**FAREHAM BOROUGH COUNCIL: LAND SOUTH OF FUNTLEY ROAD, FUNTLEY
APPLICATION REF: P/20/1168/OA**

SUPPLEMENTARY LANDSCAPE CONSULTATION RESPONSE

Figure 1: Extract of Ordnance Survey Explorer Map showing contour alignment

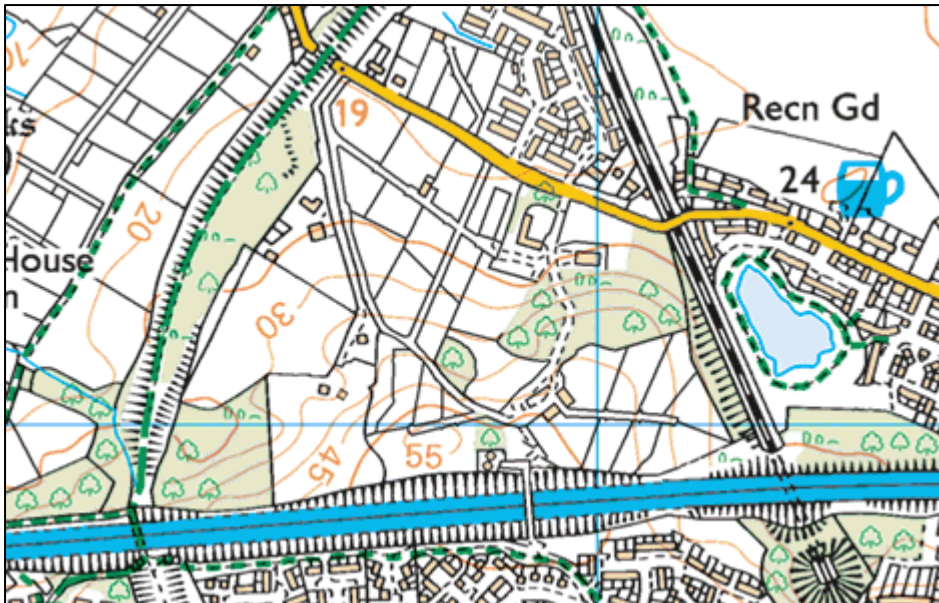
The following section of the Further Landscape Response goes on to state in the next paragraph, however, that the gradient of the slope becomes more pronounced at the 30m contour. I would question with this point, as an inspection of the Ordnance Survey mapping for the area, reproduced as Figure 1 below, shows the gradient to uniformly rise above the 25m contour (shown more darkly on the map), and this was confirmed by my site observations.
